RE: Response to Department of Planning, Industry and Environment comments

Eco Logical Australia Pty Ltd (ELA) has been asked by Architectus on behalf of the Department of Education to provide an explanation regarding the comments provided by the Environment, Energy and Science Group (EES) in the Department of Planning, Industry and Environment (DPIE) following their review of the Biodiversity Development Assessment Report (BDAR) version 4 prepared by ELA (last updated on 10 March 2020) for the Chatswood Education Precinct State Significant Development (SSD) application (SSD 9483).

Figure 1: Snippet of Six Maps topographic map baselayer showing development site in blue square

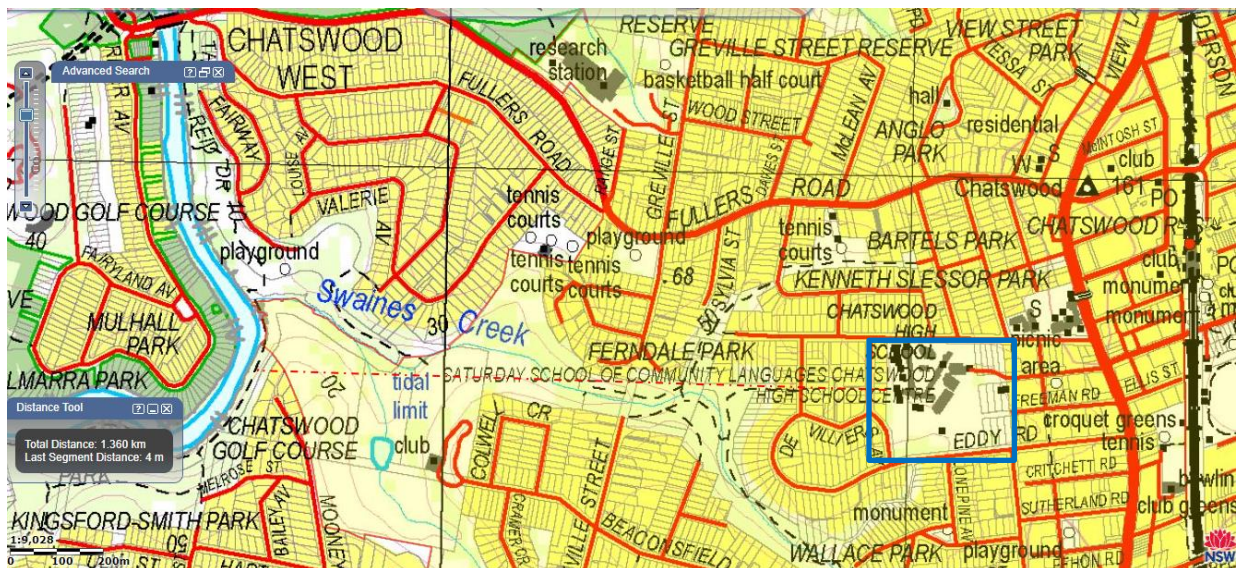
Section 1.3.2 states that “The development site falls within the Pennant Hills Ridges and Port Jackson Basin Mitchell Landscapes The Pennant Hills Ridge Mitchell Landscape has been mapped over site 2 and a portion of site 1 (Figure 2). The majority of site 1 is represented by Port Jackson Basin Mitchell Landscapes. The Port Jackson landscape has been used in the BAM Calculator for both cases.” However, EES considers that the Pennant Hills Ridges is the more appropriate NSW Landscape that should be selected, considering:

- the documented limitations in spatial accuracy of mapped boundaries of NSW Landscapes (Eco Logical 2008; Mitchell 2009)
- comparison with the boundaries of the soil landscapes in the higher resolution mapping of the Sydney 1:100,000 map sheet (Chapman et al. 1989) and its description of the Glenorie (gn) soil landscape, which is the soil landscape acknowledged in section 1.4.2.1 of the BDAR that applies to the entire subject site and is used as one of the rationales for determining PCT 1237 to be present across both sites 1 and 2, and
- distribution of PCT 1237, as mapped in the Sydney Metropolitan vegetation mapping (v.3, OEH 2016) as vegetation community S_WSF01 Blue Gum High Forest, predominantly on the Glenorie soil landscape.

As such, EES recommends the BAM assessment(s) be amended accordingly as this may alter the number of biodiversity credits required to offset unavoided impacts.

ELA included Port Jackson Basin Mitchell Landscape as the most appropriate based on the larger extent of the site covered by this landscape as per the BAM operation manual Stage 1. Which states: “if the subject land is located within more than one BioNet NSW Landscape, the assessor should select the BioNet NSW landscape in which the largest proportion of impact will occur.”

ELA also understands that the Operational Manual also states that if an adjacent landscape more accurately reflects the landscape based on field observation then it should be chosen, and justifications provided in the BDAR.

The landscape is currently in a highly urbanised environment in Chatswood. A small patch of remnant vegetation is located in the southern and western portion of development site however, this portion of the site was not included in the area to be impacted. The remaining areas were subject to substantial alternation of the soil profile and planted native vegetation.

ELA has updated the assessment based on Pennant Hills Ridge Mitchell Landscape in both of the development cases.
